SAS 2.0 Comment Resolution

- **Dimensions provided for the addition of a Plug Key & Guide Keyway for Longer Copper Cables for mini SAS 4x (Further name definition required)**
- **Need approval from STA that the addition of a second icon, identical to the current icon be added to the Plug to identify this application**
- **Tolerances for the features described here reside in Table 6-6 and Figure 6-7 of SFF-8088**
- **These features will be added to SFF-8088 Rev 3.x and new figures provided for SAS 2.0 after approval**

SAS 2.0 Plug Key

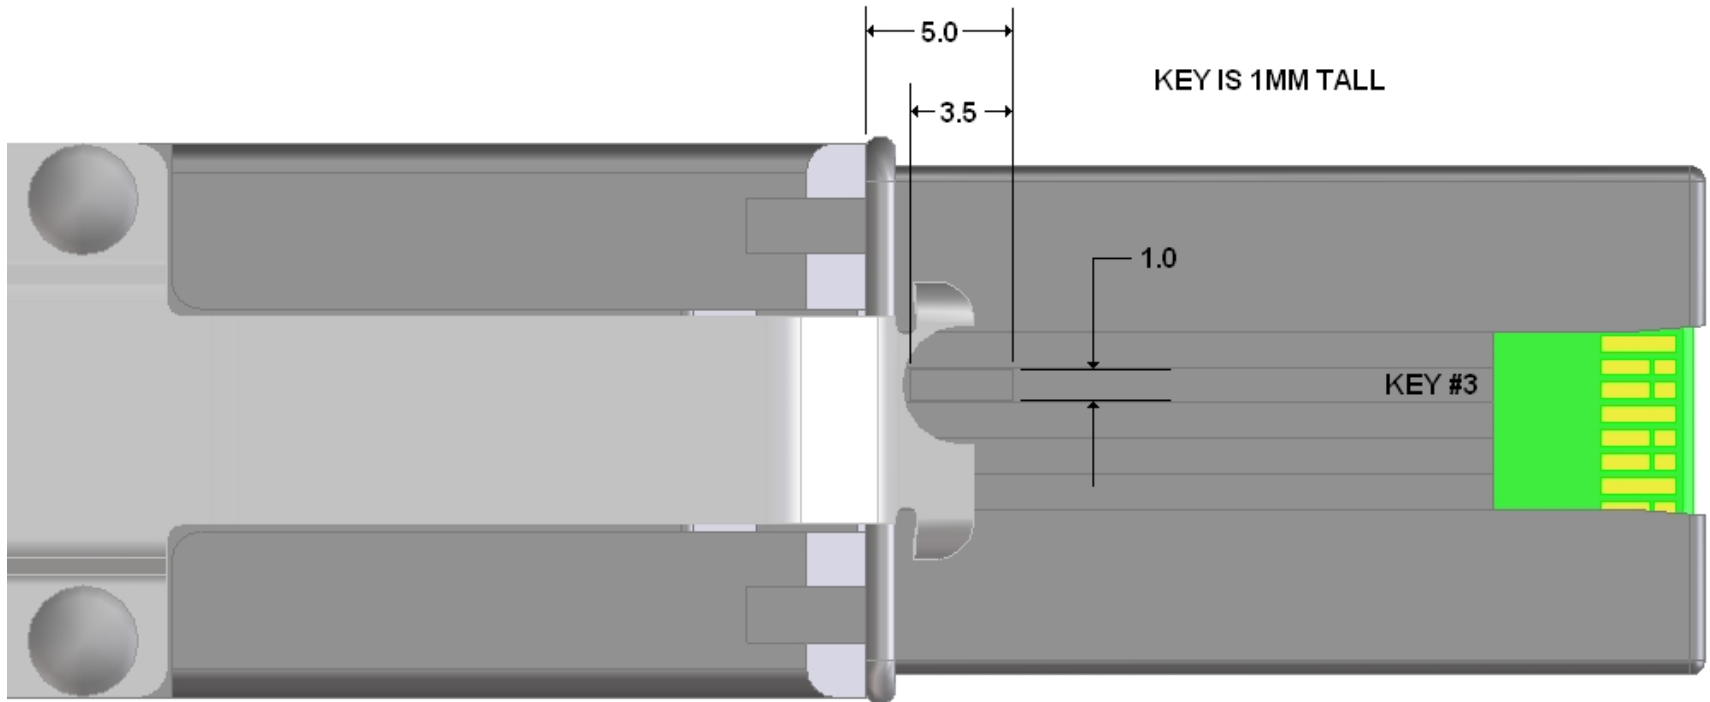
Location & Detail tolerances from SFF-8088 Table 6-6 and Figure 6-7 apply.
This detail will be added to SFF-8088 in Rev 3.1

LATCH CUT AWAY FOR VIEWING ACCESS
TOLERANCE = +/-0.1MM

SAS 2.0 Guide Keyway

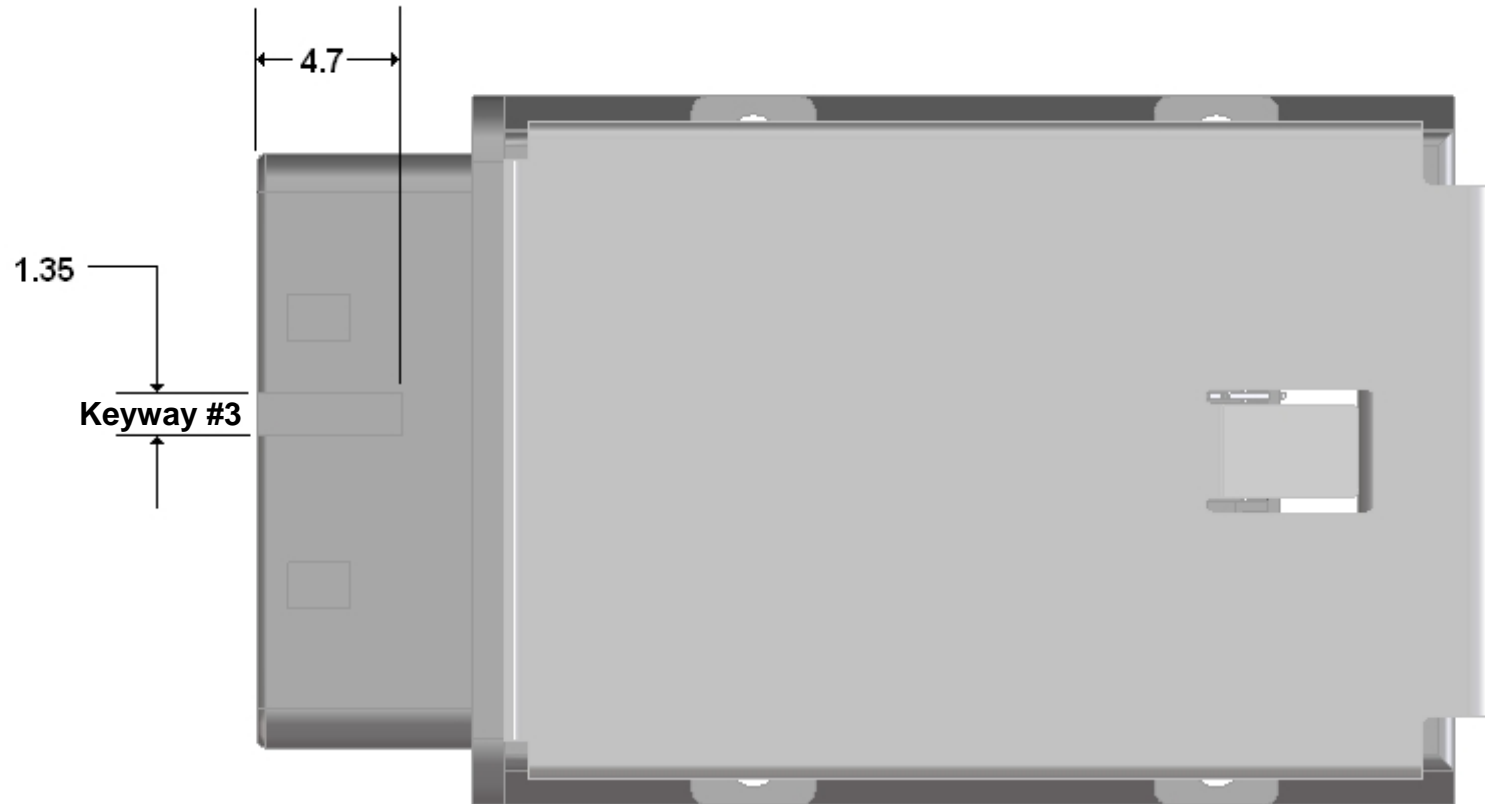
Location & Detail tolerances from SFF-8088 Table 6-6 and Figure 6-7 apply.
This detail will be added to SFF-8088 in Rev 3.1

CAGE GASKET REMOVED FOR CLARITY
TOLERANCE = +/-0.1MM
